21-177AFDP – AMERICAN SHARE INSURANCE – SIGN

Review and approval of an approximately 13.4-square-foot ground sign for an existing office building.

21-177AFDP
Amended Final Development Plan
American Share Insurance
5656 Frantz Road

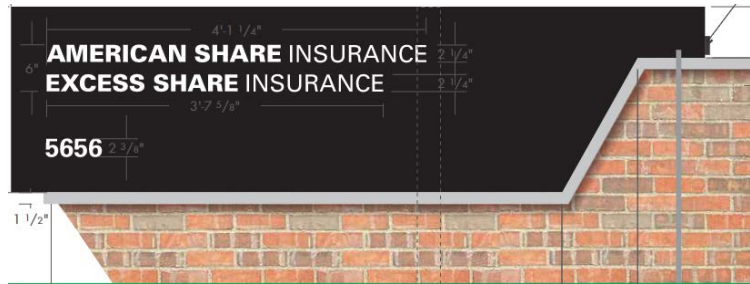
The applicant is proposing an approximately 13.4-square-foot monument ground sign located on the west side of the property, replacing the existing 20-square-foot ground sign. The smaller sign meets the maximum 50-square-foot limit for office uses. The sign is 8 feet in width, 14 inches in depth, and 3 feet in height, meeting the maximum 15-foot height limit. The sign is located approximately 14 feet - 3 inches from the property line, meeting the minimum 8-foot setback required by Code.

The proposed black aluminum sign cabinet will be affixed to an approximately 2.5-foot tall brick base with a limestone cap and mounted to a concrete foundation. The applicant should match the brick base to the existing brick on the building. The sign copy is translucent white acrylic letter pushed through the sign face by 0.75 inches. The copy is internally illuminated with white light and will be controlled by a controlled time clock. The sign also includes the address of the property below the copy of the business.

The City of Dublin Zoning Code requires a 3-foot perimeter around monument signs to provide some visual buffering from the base of the sign. There is existing landscaping surrounding the existing sign that includes a mulch base with evergreen shrubs and pine trees. The applicant will work with Staff to assure landscaping compliance for the new ground sign that will be reviewed as part of the sign permit process.

- 1) The applicant work with Staff to assure landscaping compliance for the new ground sign that will be reviewed as part of the sign permit process;
- 2) The applicant match the brick base to the existing brick on the building.; and,
- 3) The applicant obtain a Sign Permit through Building Standards prior to replacement of the ground sign.
